**RFB: 23-0029**

**ADDENDUM NUMBER THREE**

To The Drawings and Specifications for  
**Sedgwick County Courthouse**  
**Cooling Tower Replacement**

Issued: May 17, 2023

SHEET  
**A1.1**  
OF SHEETS

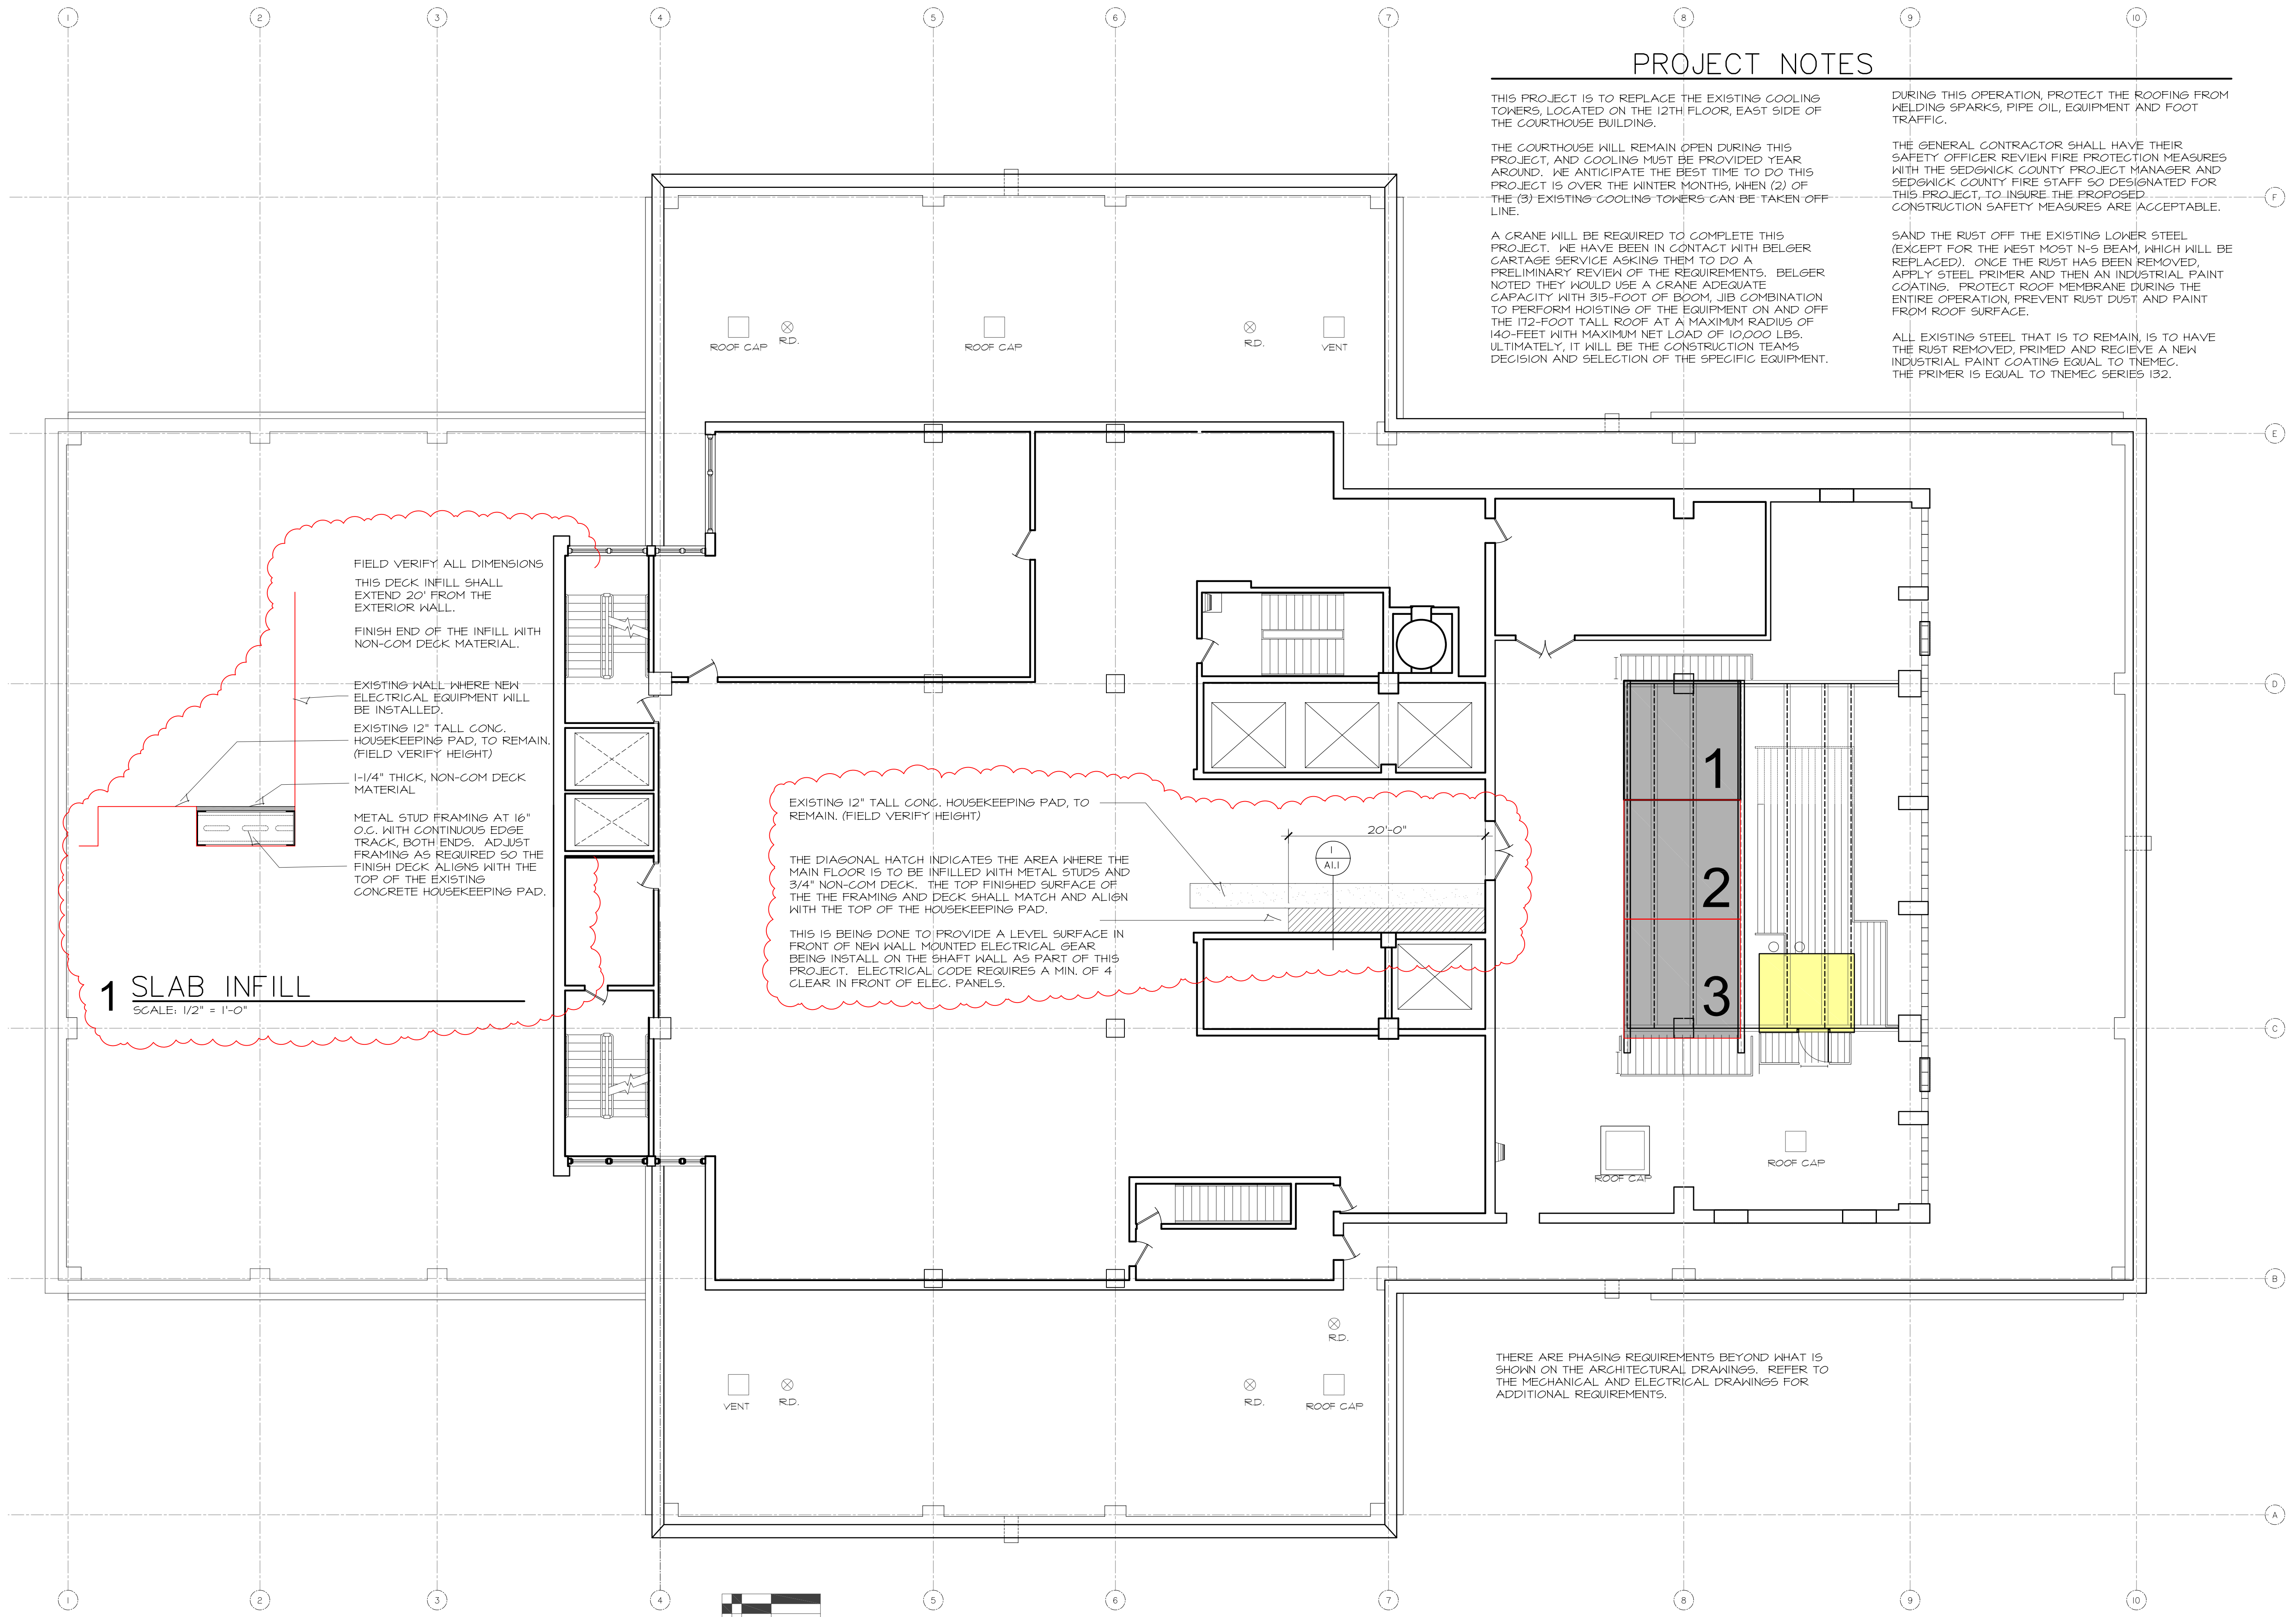
- 2.1 Sheet A1.1  
This sheet is being reissued with this addendum.  
Sheet A1.1 was modified to add an illustration and detail of floor infill that is required for the new electrical gear being installed on the south wall of the access hall to the exterior cooling towers.
- 2.2 Sheet M2.1  
Each tower basin shall receive a basin heater. Starter shall be by Electrical Contractor.
- 2.3 Sheet E2.1  
Detail 1, a weatherproof Ground-Fault Circuit Interrupter Receptacle (GFCI) shall be added on the west and east sides of the new cooling towers, to meet the requirements of the N.E.C. Section 210.8(B)(3), 210.63(A) and 406.9(B)(1).

FIELD VERIFY ALL DIMENSIONS  
THIS DECK INFILL SHALL  
EXTEND 20' FROM THE  
EXTERIOR WALL.  
FINISH END OF THE INFILL WITH  
NON-COM DECK MATERIAL.

METAL STUD FRAMING AT 16"  
O.C. WITH CONTINUOUS EDGE  
TRACK, BOTH ENDS. ADJUST  
FRAMING AS REQUIRED SO THE  
FINISH DECK ALIGNS WITH THE  
TOP OF THE EXISTING  
CONCRETE HOUSEKEEPING PAD.

THE DIAGONAL HATCH INDICATES THE AREA WHERE THE  
MAIN FLOOR IS TO BE INFILLED WITH METAL STUDS AND  
3/4" NON-COM DECK. THE TOP FINISHED SURFACE OF  
THE FRAMING AND DECK SHALL MATCH AND ALIGN  
WITH THE TOP OF THE HOUSEKEEPING PAD.

THIS IS BEING DONE TO PROVIDE A LEVEL SURFACE IN  
FRONT OF NEW WALL MOUNTED ELECTRICAL GEAR  
BEING INSTALLED ON THE SHAFT WALL AS PART OF THIS  
PROJECT. ELECTRICAL CODE REQUIRES A MIN. OF 4'  
CLEAR IN FRONT OF ELEC. PANELS.
